LIMESTONE REVISIONS NOTE:

DOUGLAS STREETSCAPES
PROJECT NAME

TOWER DETAILS
SHEET TITLE

DATE	JOB NO.	SHEET/OF
OCT '95	SWA MKC-251	LS 6.03

4 TYPICAL SECTION
1/2" = 1'-0"

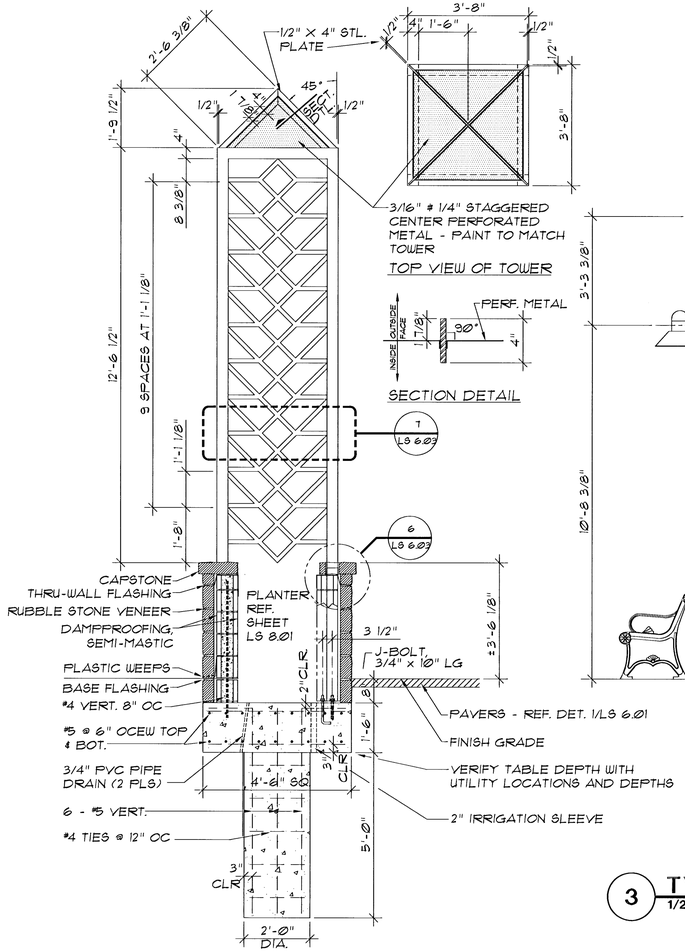
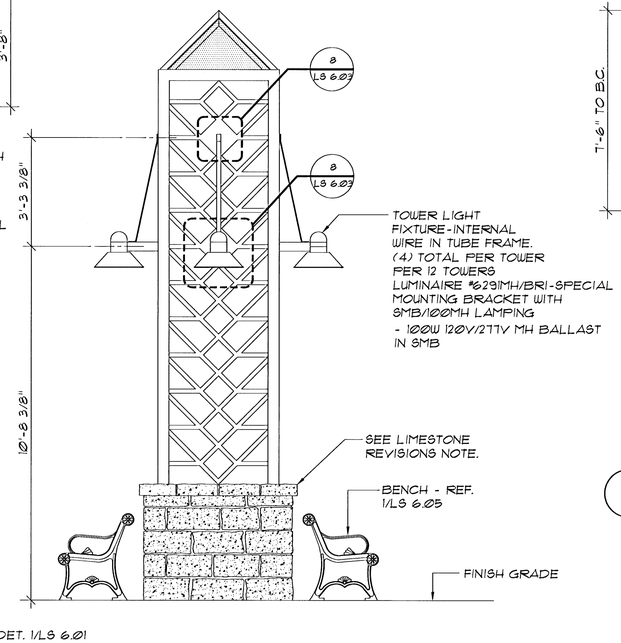
In lieu of Rubble Limestone, the stone veneer pattern is to be of approximately equal 8" height horizontal courses, with random 12" to 18" ± face lengths with staggered vertical joints. Texture of face and ends where exposed shall be Natural Cleft, Pitched Face. Bed thickness to nominal 3 3/4"-4".

In lieu of the 4" height (vertical dimension) cap stone, provide 8" height cap stone, with Natural Cleft, Pitched Face, texture on face, and ends where exposed. Texture on top surface of cap stone to be Natural Cleft, Pitched Face if possiblet or Split Face is acceptable on the top surface. The face of the cap stone is to be in approximately the same plane as the stone face below versus the 1 1/2" overhang as detailed.
